Rep No. B25058a
September 10, 2026
Fuji Electric FA Components
& Systems Co., Ltd.

Notification of Change of Country of Production for New SC, NEO SC, and SC-NEXT Series Magnetic Contactor and Magnetic Starter Options [Revised Version]

Product name	Coil-surge suppression units
Series name	SC-NEXT Series, New SC Series, NEO SC Series, SK Series, SC-E Series
Types	SZ-Z□ □: 1, 2, 3, 4, 5 31, 32, 33, 34, 35, 36, 37 The above types will be produced in Japan or China. 41, 42, 43, 44, 45, and 46 will continue to be produced in Japan. *Including applicable products starting with these product types.
Changed parts	Printing and packaging specifications will depend on the country of production and production location.
Details of the change	The country of production of coil-surge suppression units will be either Japan or China. With the addition of China as a production base, the following differences will exist depending on the production location. O Change in product printing content: Refer to Attachment 1 O Change in packaging label: Refer to Attachment 2 Please check the country of production on the product printing content and packaging label (For details, refer to the attachments). The

Change in Product Printing Content

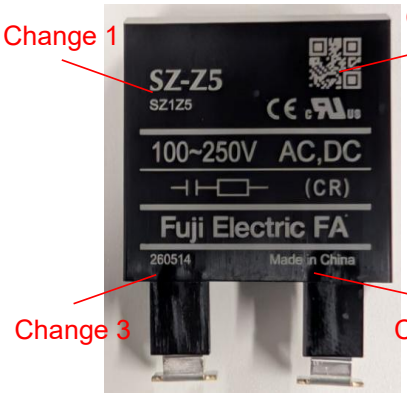
1. The printing method will be changed from permanent ink to laser printing.
2. 2D code will be added to improve internal management.
3. The diagram number will be removed and the production lot will be added (The production lot currently printed on the side of the product will be removed).
4. Country of production will be changed from Japan to China.
